INDEPENDENT ADVISORY
PANEL FOR UNDERGROUND
MINING

**METROPOLITAN MINE
LONGWALLS 308 - 310
EXTRACTION PLAN**

September 2022

Figure 2: Predicted conventional vertical displacements, tilts and strains over the southern portion of LW308 to LW310 after LW311 to LW313 have been extracted.

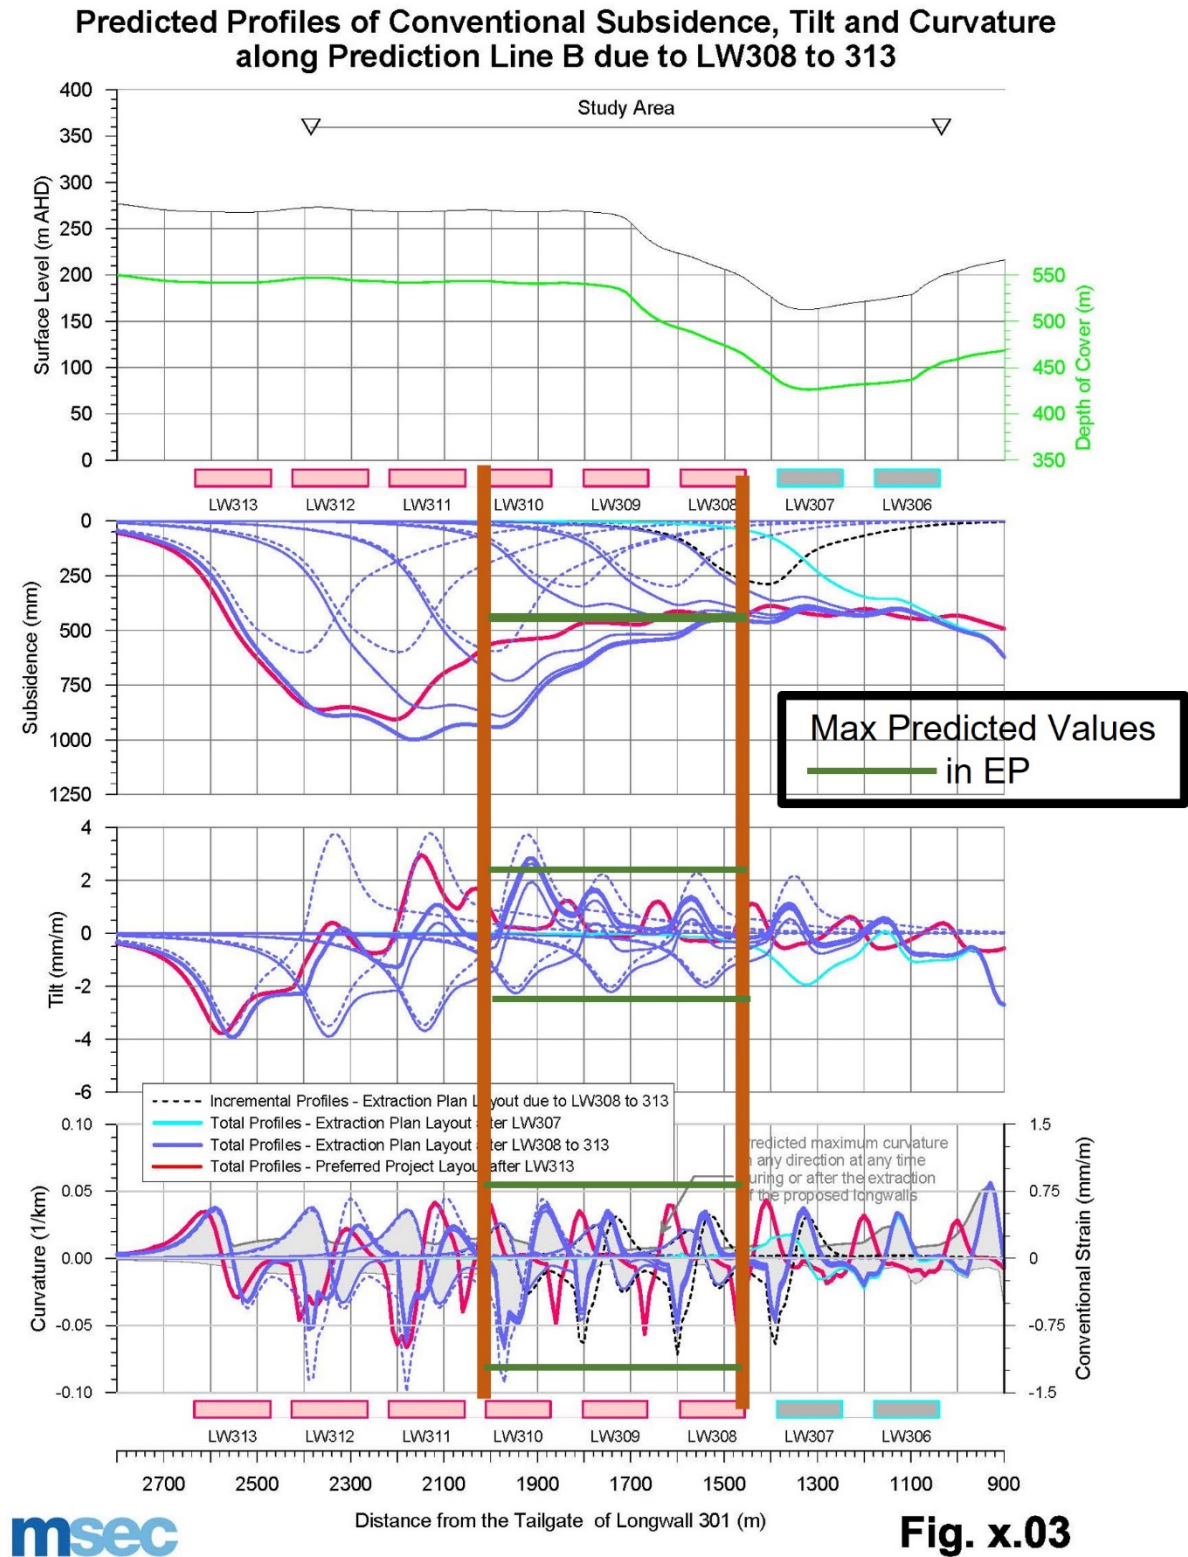
However, the Panel notes that the subsidence predictions presented in the Extraction Plan are incomplete in that they do not take account of the additional subsidence that may develop over LW308 to LW310 when subsequent longwall panels are extracted. In particular, the planned

Further information from the Applicant on this matter included Figure 2, which the Panel has annotated to show that the subsequent extraction of LW311 to LW313 is predicted to result over LW310 in around a doubling of maximum vertical surface displacement (from 475 mm to about 950mm), an increase of about 1.5 mm/m in maximum (transient) tilt to 4 mm/m and a marginal increase in permanent tilt, and a marginal increase of about 0.15 mm/m in maximum (transient) compressive strain. The additional information did not address non-conventional subsidence. For watercourses, the additional subsidence could possibly result in increases in valley closures and strains, thus increasing the risk of fracturing and, where the watercourses flow through swamps (e.g. Swamp 82), knock-on risks to swamps. However, the Extraction Plan already acknowledges that the watercourses overlying LW308 to LW310 will experience the full range of subsidence impacts.

The Panel recommends that the Extraction Plan be updated to include:

1. incremental, transient and cumulative predictions of both conventional and non-conventional surface subsidence parameters for LW308 to LW310 over the projected life of the mine;
2. a reassessment of the impacts and consequences associated with these revised subsidence predictions.

Figure 3: Predicted Versus Observed Valley Closure at Metropolitan Coal and other Southern Coalfield Mines (copied from supplementary information provided by Peabody to DPE 17/08/22).

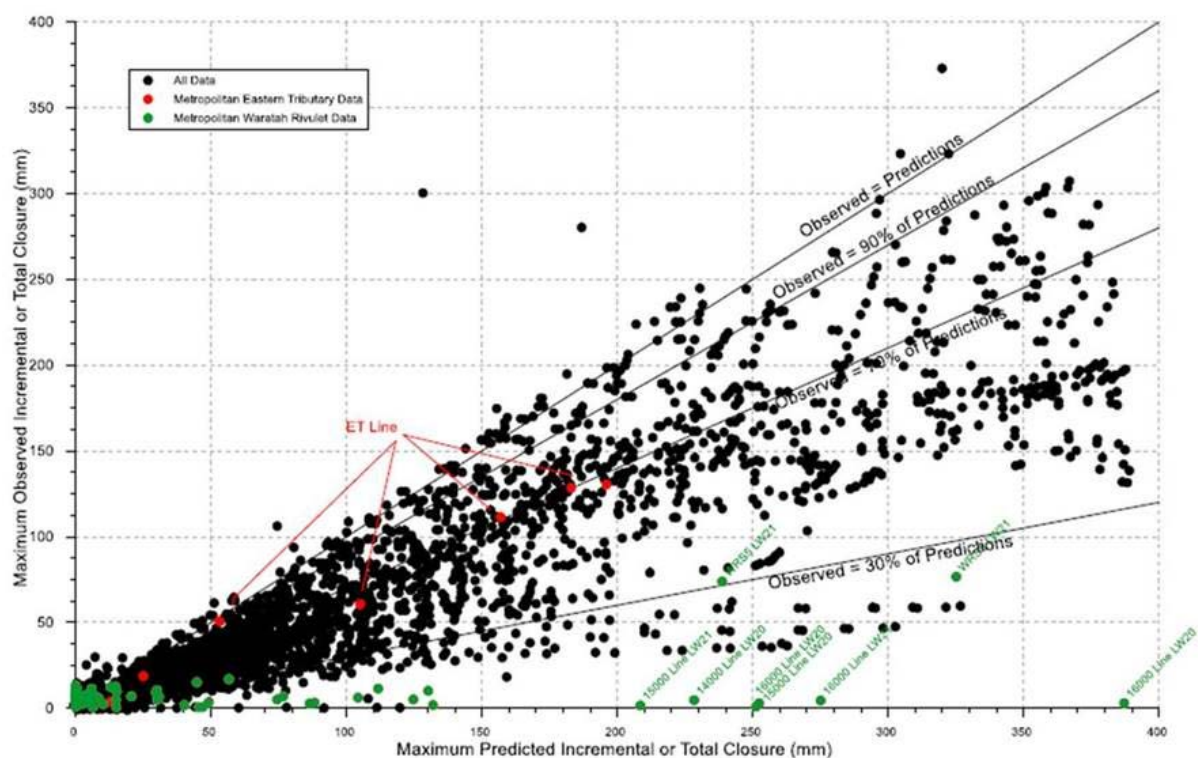
In the proposed Waratah Rivulet TARP, level 1, 2 and 3 triggers are based on measured valley closures of 100 mm and 150 mm (50 and 75% of the predicted valley closure of 200 mm that is associated with no previous impacts to the Waratah Rivulet). As recognised by the Extraction Plan (“*With the conservative nature of valley closure predictions, observed valley closure is typically lower than predicted valley closure*”) the 100 mm and 150 mm triggers are likely to translate to higher values of predicted valley closure. Supplementary information provided by Peabody⁴, Figure 3 in this advice, shows that for Waratah Rivulet, observed valley closures have in all plotted cases been below 80 mm, but with corresponding predicted valley closure up to approximately 390 mm. Therefore, based on the available information including that contained in Figure 3, the proposed 100 mm and 150 mm observed valley closure trigger values are unlikely to be surpassed but if they are surpassed this presents a moderate to high risk of a Type 3 fracture. The Eastern Tributary TARP was based on considerably more sophisticated monitoring and assessment and relatively risk-averse observed valley closure values. Its success should not be used to justify the proposed Waratah Rivulet TARP. Against this background, the Panel does not concur with WaterNSW’s view that the proposed trigger levels are appropriate for performance assessment.

are unlikely to indicate increasing likelihood of a Type 3 fracture before the fracture occurs and these triggers are not sufficiently justified in the Extraction Plan or in supplementary information provided to the Panel.

The Panel recommends that the Level 1, Level 2 and Level 3 observed valley closure trigger values are revised and justified based on re-consideration of the relationship between risk of Type 3 impacts and observed valley closure at the Waratah Rivulet.
